Work Order ID 104668

Item Name: Fwd Crosstube - High

DRAWING NO. D212-664-141	TITLE XTUBE ASSY (205/212/412 HI FWD)	REV. D	DART AEROSPACE LTD ENGINEERING ORDER		D.E.O. NO. D212-664-141-D-1	SHEET NO. SHEET 1 OF 2	SCALE NTS
DRAWN	CHECKED	OP	MFG. APPR.	1	APPROVED	NA	DE APPR.
DATE 11.04.07	DATE 11.07.11		DATE 11.04.12		DATE 11/04/12		DATE 11.04.12

**D212-664-141/-141B  
ASSEMBLY DETAIL**

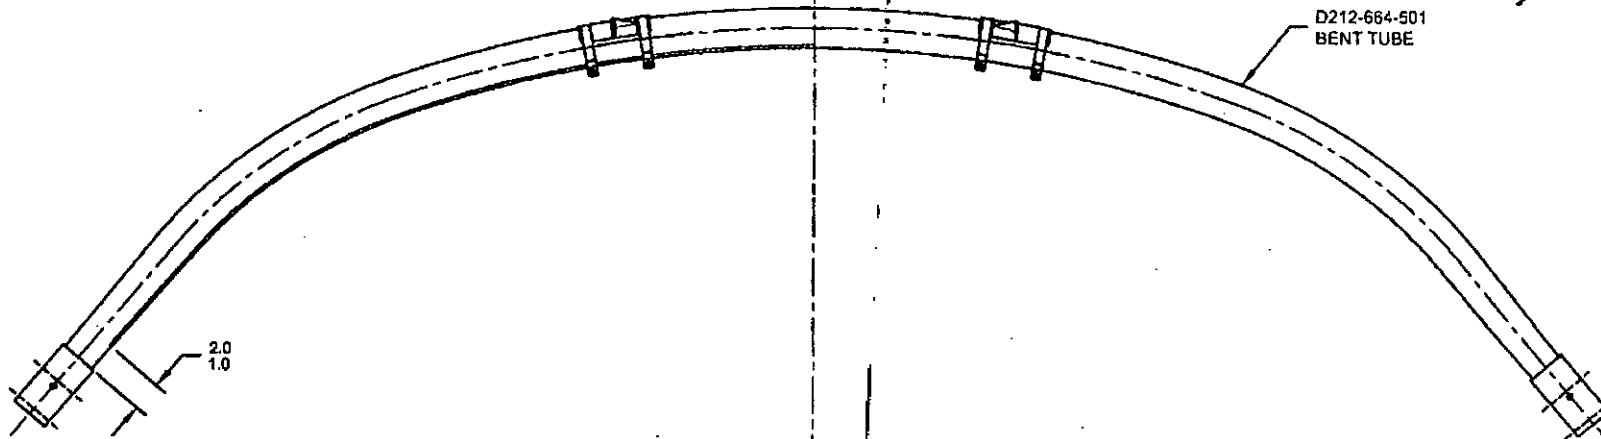
ADD AN INSPECTION WINDOW TO UNDERSIDE OF CROSSTUBE.

NOTES 2 OF SHEET 1 IS AMENDED AS FOLLOWS:

- 2) FINISH: CHEMICAL CONVERSION COAT PER DART QSI 005 4.1  
PRIME INSIDE AND OUTSIDE PER DART QSI 005 4.2  
MASK UNDERSIDE OF CROSSTUBE AS SHOWN (HATCHED AREA) AND  
PAINT OUTSIDE PER DART QSI 005 4.2  
REMOVE MASKING AND APPLY CLEAR COAT

MASK AREA PRIOR TO PAINTING,  
REMOVE MASKING AFTER PAINT  
AND APPLY CLEAR COAT
